Product Change Notification / SYST-08HQLN222

ERRATA - PIC32MZ Embedded Connectivity with Floating Point Unit (EF) Family Silicon Errata and Data Sheet Clarification

PIC32MZ Embedded Connectivity with Floating Point Unit (EF) Family Silicon Errata and Data Sheet Clarification

FIGURE 1: Posc CRYSTAL CIRCUIT

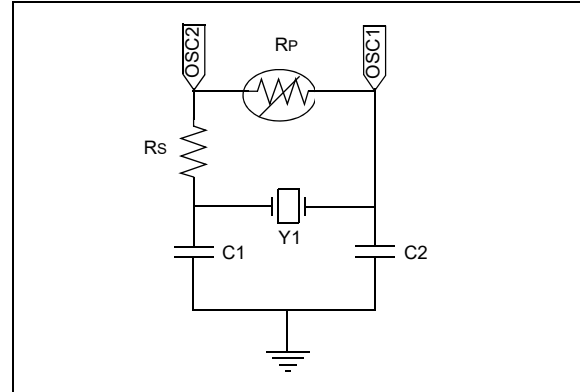
Revision A3 and B2 Silicon: The Posc has been tested in a normal power-up sequence and supports specific crystal operation.

The Primary Oscillator (Posc) has been characterized to operate at 8 MHz, 12 MHz, and 24 MHz when the circuit in [Figure 1](#) is implemented, and the operating conditions listed in [Table 3](#) are met.

Crystal Frequency (see Note 1)	Series Resistor (Rs)	Posc Gain Setting POSCGAIN<1:0> (DEVCFG0<20:19>)	Posc Boost Setting POSCBOOST (DEVCFG0<21>)
8 MHz	2 kΩ	'0b00 (GAIN_0)	'0b1 (ON)
12 MHz	1 kΩ	'0b00 (GAIN_0)	'0b1 (ON)
24 MHz	0 kΩ	'0b00 (GAIN_0)	'0b1 (ON)

- Note 1:** Using any other crystal frequency will require special component selection and characterization.
2: A parallel resistor (Rp) should not be used to increase the gain of the POSC.

64-PIN QFN⁽⁴⁾ AND TQFP (TOP VIEW)

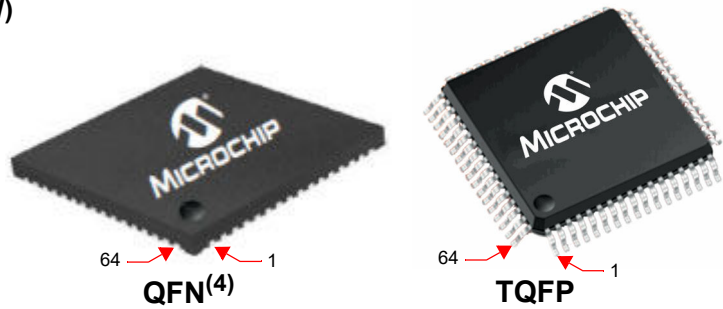
In Table 2. “Pin Names for 64-pin QFN and TQFP Devices” of the current data sheet, the AECRS_{DV} signal was erroneously omitted from the pin number 44 and added to the pin number 62. The correct assignment is shown in bold type in the following table.

Pin #	Full Pin Name	Pin #	Full Pin Name
29	AN9/RPB14/SCK3/PMA1/RB14	61	TRD1/SQID1/ERXD0/PMD1/RE1
30	AN10/EMDC/AEMDC/RPB15/OCFB/PMA0/RB15	62	TRD2/SQID2/ERXDV/ECRSDV/PMD2/RE2
31	OSC1/CLKI/RC12	63	TRD3/SQID3/ERXCLK/EREFCLK/RPE3/PMD3/RE3
32	OSC2/CLKO/RC15	64	AN18/ERXERR/PMD4/RE4
